H. B. ROBINSON STEAM ELECTRIC PLANT, UNIT NO. 2  
DOCKET NO. 50-261/LICENSE NO. DPR-23 -

RESPONSE TO NRC REQUEST FOR ADDITIONAL INFORMATION  
REGARDING PROPOSED TECHNICAL SPECIFICATIONS CHANGES TO SECTION 3.3

**RESPONSE TO NRC REQUEST FOR ADDITIONAL INFORMATION REGARDING  
 PROPOSED TECHNICAL SPECIFICATIONS CHANGES TO SECTION 3.3**

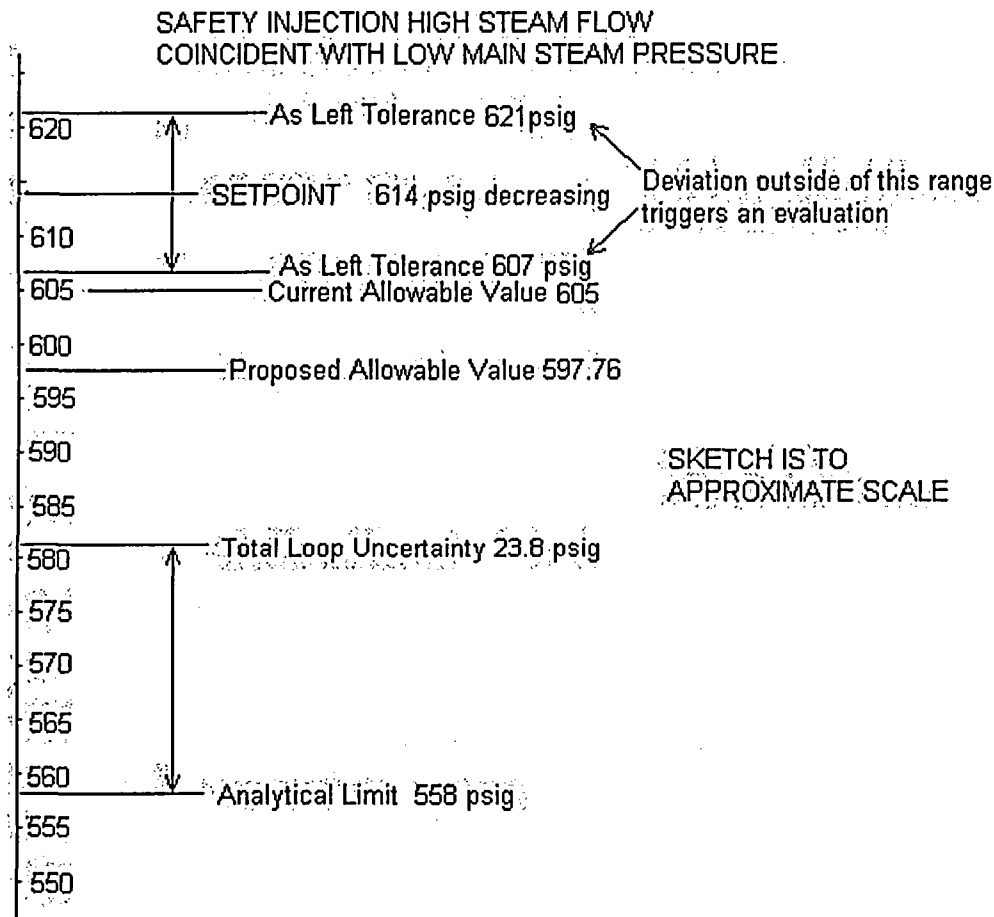
The licensee has indicated that the as-found setpoint is to be assessed against the nominal setpoint (the "target value") rather than against the previous as-left setpoint. The staff maintains that the purpose of this assessment is to evaluate the behavior of the instrument(s) as compared with the assumptions upon which the limiting setpoint was based. Assessment against the nominal value rather than against the as-left value would introduce the setting error into the assessment, and could thereby mask excessive deviation. Staff has recently determined that assessment against the nominal setpoint will yield sufficiently sensitive detection of excessive deviation if the setting tolerance (the limiting acceptable as-left deviation from the nominal value) does not exceed the limiting amount of deviation expected (exclusive of the setting tolerance) AND the setting tolerance is incorporated independently into the total loop uncertainty upon which the limiting setpoint is based. If the licensee wishes to retain assessment against the nominal setpoint, then it must be shown that the setting tolerance is suitably constrained.

The following figure and description is provided as an illustration of channel parameters:

The as-found tolerance range as shown in this figure (which, as previously described, is chosen to be the same as the as-left tolerance range) is approximately  $\pm 7$  psig of the nominal trip setpoint of 614 psig. There is substantial margin to the analytic limit for this function, which is 558 psig (i.e., approximately 56 psig below the nominal trip setpoint).
